<b>SB-A500A-7200-01</b>	Revision:	--
		Type:	EA 400
Model:		EA 400-500	
Project:		A500A-16-06	
Date:		24. Nov. 2016	
Design Organisation EASA.21J.551

## SERVICE BULLETIN

# ROLLS ROYCE TP CEB A-72-2091

Compliance with Rolls Royce Alert Commercial Engine Bulletin TP CEB A-72-2091Rev.5 Engine N2 Speed Avoidance Range Limitation.

### 6.1. Installation of the Instrument Panel Placard

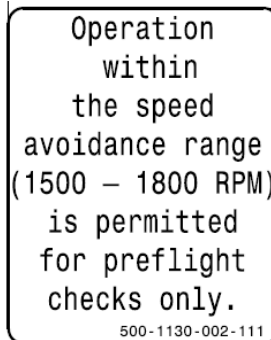
This SB replaces the existing N2 RPM limiting placard above the RPM indicator (within the MVP engine instrument) and provides operating instructions for the N2 RPM avoidance range.

- Remove the existing N2 RPM avoidance range placard installed above the MVP Instrument.
- Remove stickies and clean the panel surface in accordance with MM procedures.
- Install the new self-adhesive placard P/N 500-1130-002-111 at the same location.
